South Texas Project Electric Generating Station P.O. Box 289 Wadsworth, Texas 77483

August 19, 2010
U7-C-STP-NRC-100193

South Texas Project
Units 3 and 4
Docket Nos. 52-012 and 52-013
Revised Response to Request for Additional Information

RAI 03.08.04-18, Revision 1, Supplement 1**QUESTION:****Follow-up to Question 03.08.04-2 (RAI 2964)**

FIGURE 1.2-23A RADWASTE BUILDING AT ELEVATION -1700 MM

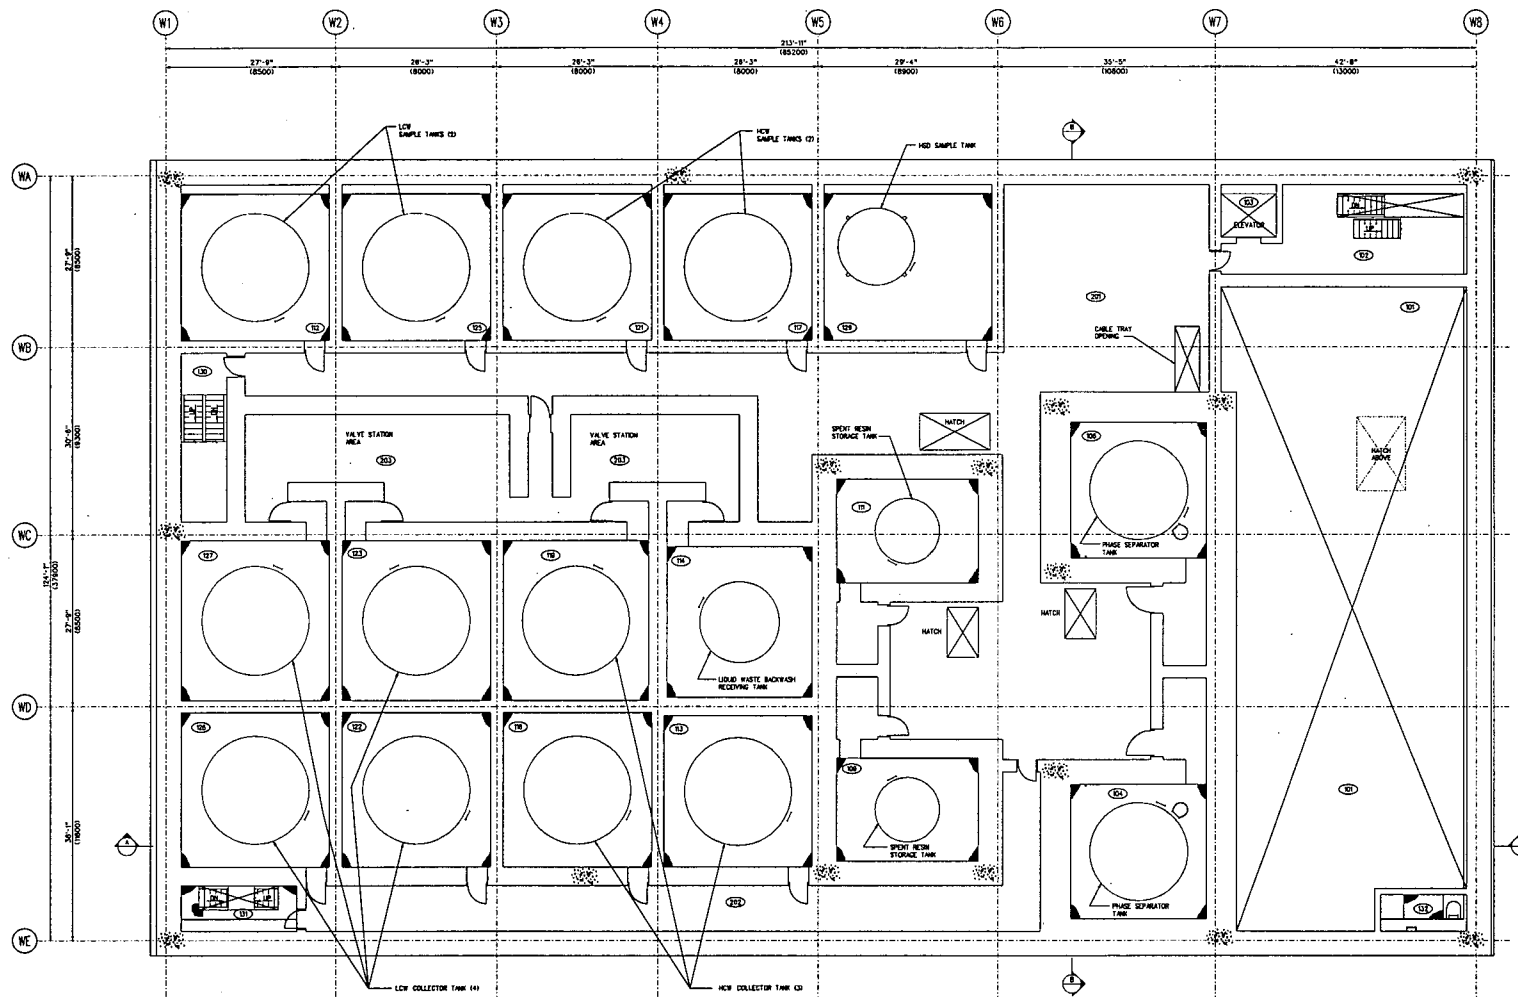
Equipment Arrangement (Figures 1.2-23a and 1.2-23b)

- The phase separator tanks and associated pumps are moved from the west end of the building to the east end. This change shortens the piping runs from the radwaste piping tunnel (which provides the connection to the Reactor Building and Turbine Building) to the tanks and from the tanks to the dewatering equipment. The shorter piping runs for this system, which has a high solids content, reduce demand on components of the system, helps prevent crud buildup, and minimize and localize the sources associated with the phase separator tanks.

- The decant pumps for the phase separator and spent resin tanks were separated from the transfer pumps and placed in separate rooms for ALARA purposes (see “Partial Floor Plan” on Figure 1.2-23a). The decant pumps are expected to handle liquid with a much lower activity than the transfer pumps, so this is an implementation of the ALARA concept of separating low activity components from high activity components.

- The two rows of tanks were shifted to the west against the west wall to utilize the space formerly occupied by the phase separator tanks. The corridor along the west wall, which was used to access the phase separator tanks, was eliminated as no longer necessary, and to save space. The removal of the corridor required the addition of a stairwell in the northwest corner of the building for life safety reasons.

- The liquid waste (LW) backwash receiving tank and associated pumps were moved from the northwest corner of the RWB to the approximate center of the RWB adjacent to the west wall of the spent resin tanks. This move also locates this tank near the other sludge tanks so that all sludge tanks are located in the same area of the RWB. This move shortens the pipe runs from the processing equipment located on the floor above, which is the primary input to the tank. This also locates the LW backwash receiving tank closer to the phase separator, which is used to process the contents of the LW backwash receiving tank. In a manner similar to the relocation of the phase separator tank, the shorter piping runs for this system, which has a high solids content, reduce demand on the components of the system, help prevent crud buildup, and minimize and localize the sources associated with the LW backwash receiving tank.

- The row of sample tanks along the north wall was shifted west to the west wall to utilize the space formerly occupied by the LW backwash receiving tank. A wall was added between the two high conductivity waste (HCW) sample tanks to provide shielding between two passive components. This provides shielding that may be required in the unlikely event that one of the HCW sample tanks becomes contaminated to ensure that the radiation zones are not adversely impacted.

- The hot shower drains (HSD) receiver and sample tanks and pumps were moved from the center of the RWB to the north wall east of the sample tanks. This move makes room for the LW backwash receiving tank in the center of the RWB and utilizes space vacated by the relocation of the LW backwash receiving tank. The HSD receiver and sample tanks are low activity tanks, and this move groups them with the low activity sample tanks. Both tanks and the pumps are accessed from El 12'-0", and the lower region serves as a stainless steel lined leak retention space similar to the other tank rooms (this is unchanged from the current design).

- The chemical drain tank and pumps were moved from the second floor (Figure 1.2-23b) to the basement (Figure 1.2-23a) along the north wall east of the HSD tanks. This made use of available space and freed up space for a valve aisle on the second floor (this places the valves and pumps in separate rooms to reduce radiation exposure). When combined with the relocation of the HSD tanks, all low activity tanks are located along the north wall of the RWB (this will facilitate operations and reduce operational radiation doses).

FIGURE 1.2-23B RADWASTE BUILDING AT ELEVATION 5300 MM

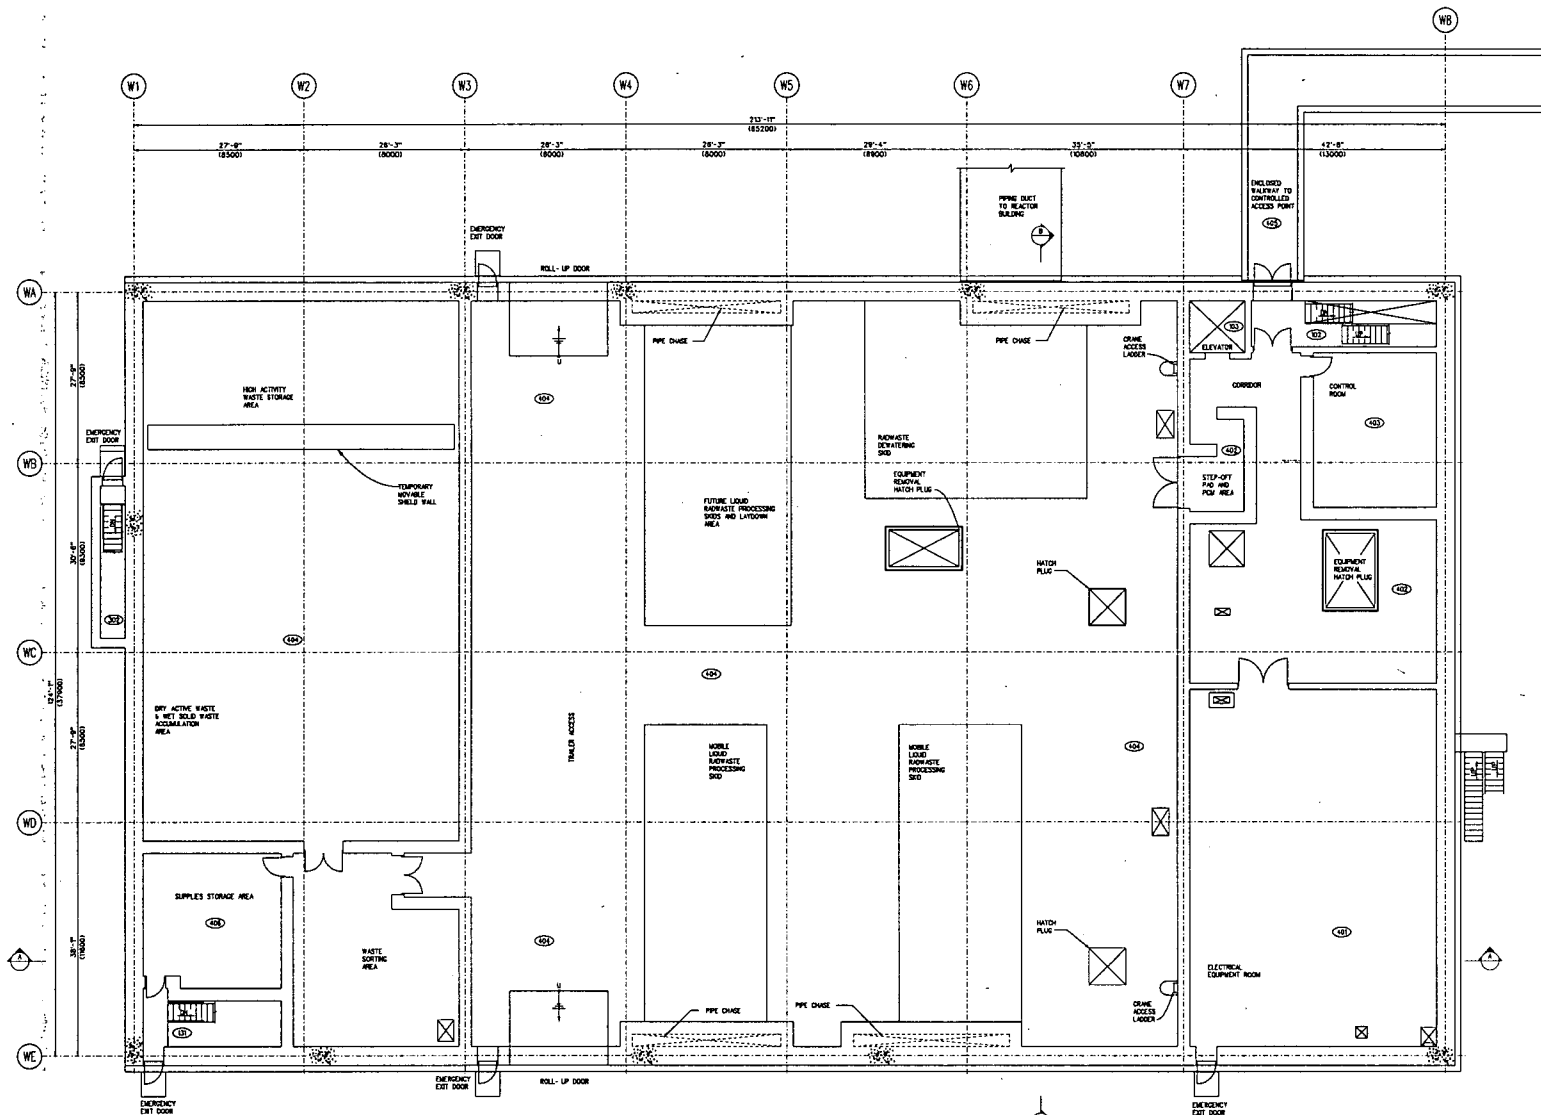
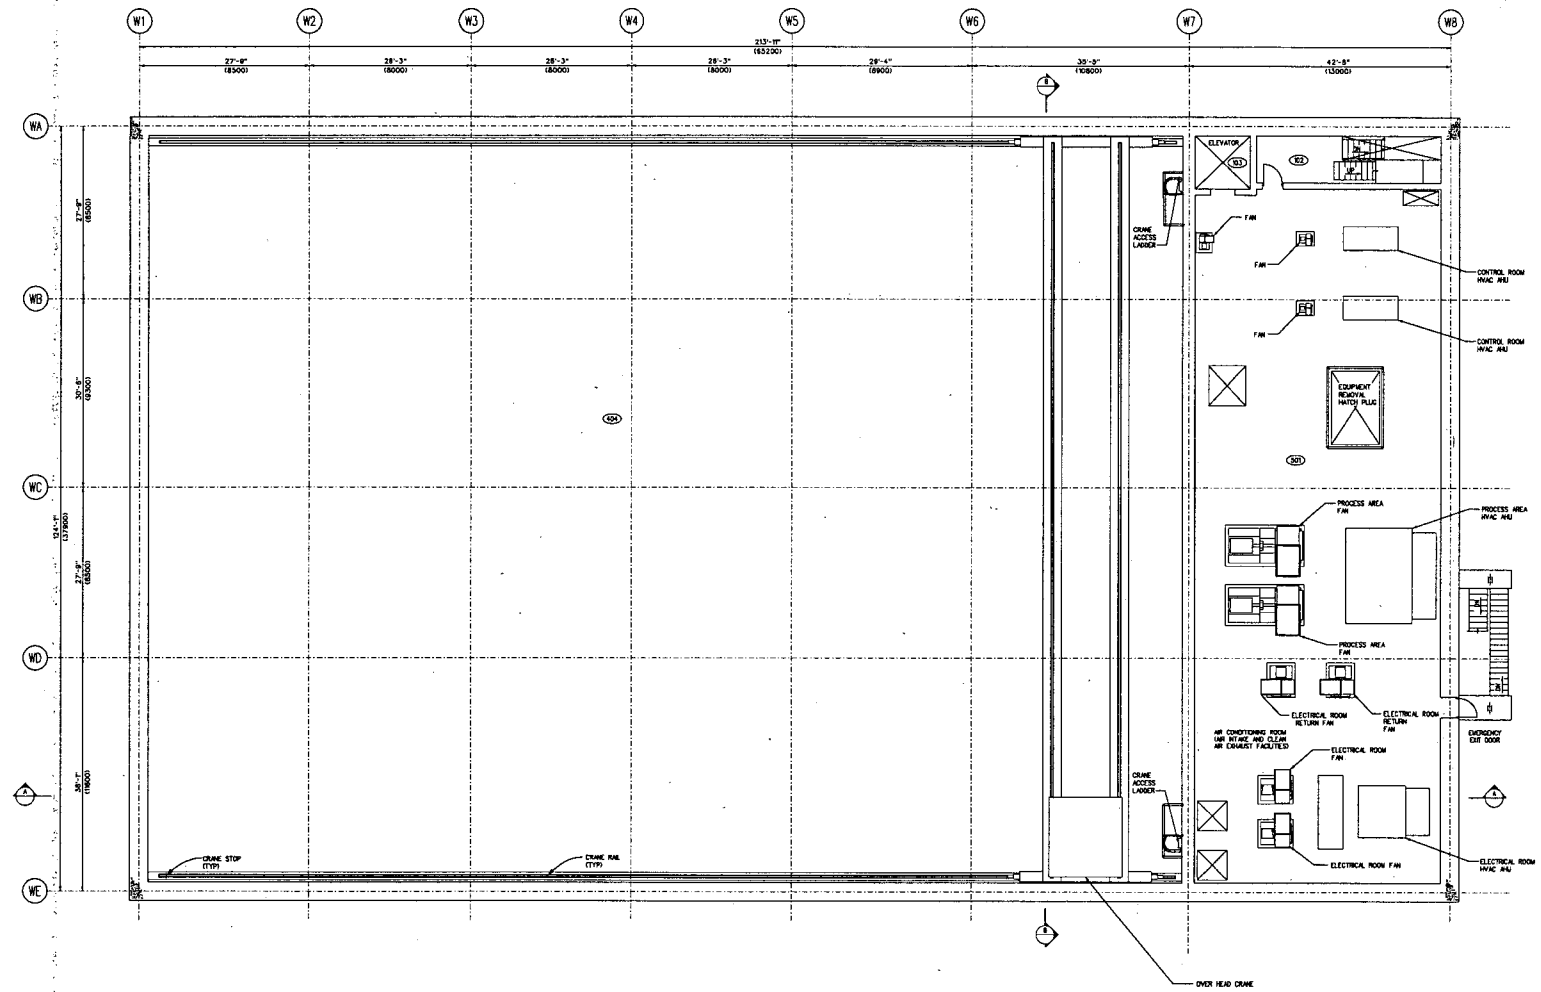
- The electrical equipment room was moved from the El 5300 mm floor (Figure 1.2-23b) to the Grade floor (Figure 1.2-23c) to locate it adjacent to the control room (this places the clean electrical areas in adjacent locations). The area on the El 5300 mm floor is now used as a cable spreading area (this will facilitate construction and maintenance).

FIGURE 1.2-23E RADWASTE BUILDING, SECTIONS A-A, B-B (SHEET 1)

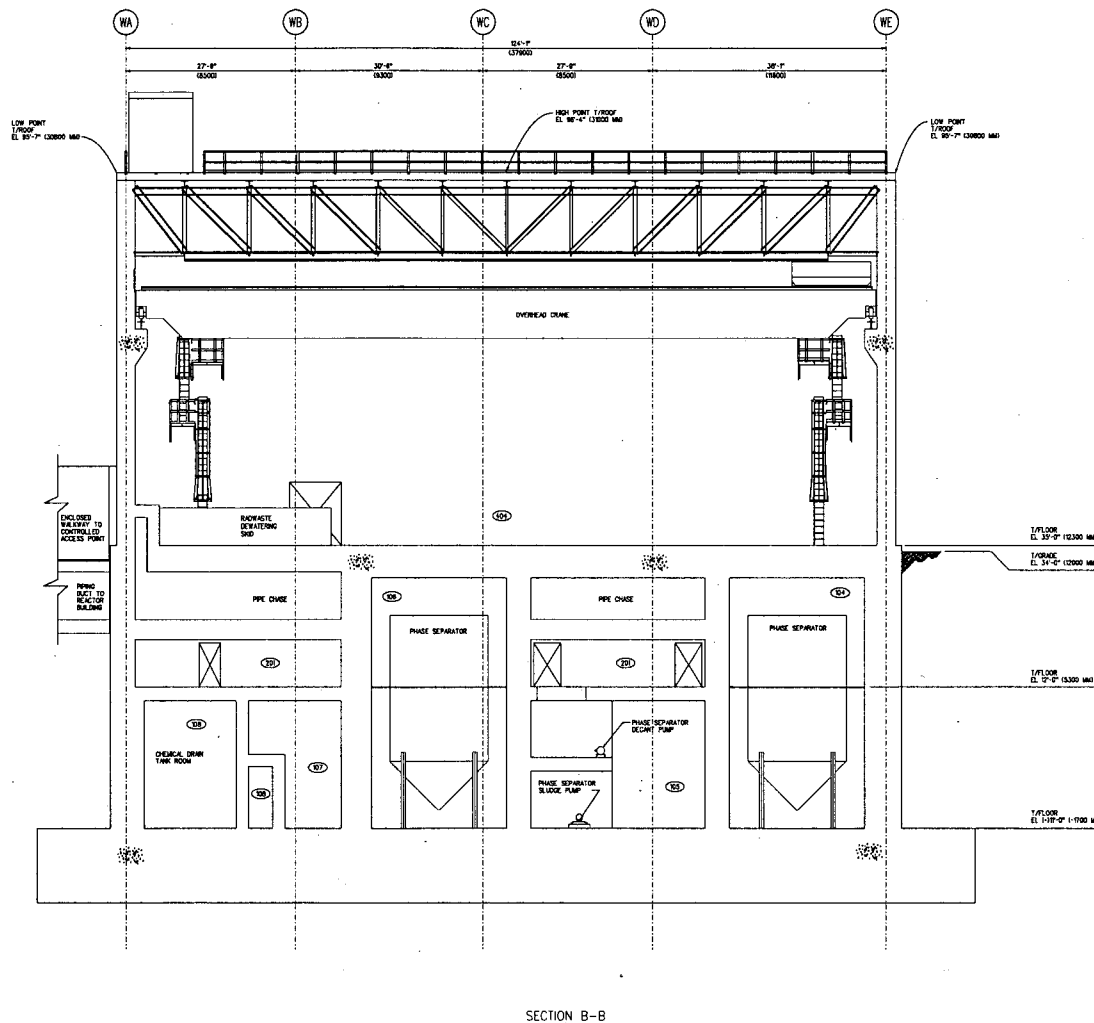
Building Size (Figure 1.2-23e)

- The height of the roof above the ground floor has increased from 44'-0" to 61'-4" to accommodate the size and lifting height requirements of the overhead crane. This will improve the operability of the facility (e.g., radioactive waste cask loading operations) by increasing the crane hook clearance.
- The changes in thickness of the RWB outside walls and the configuration of the basement as shown in the revised Figure 1.2-23e are based on the detailed structural analysis. The interior dimensions of the RWB are not changed.

- The section views on Figure 1.2-23e were separated onto two sheets (maintaining the same figure number) to improve legibility as required for the larger scale used for the revised figures.
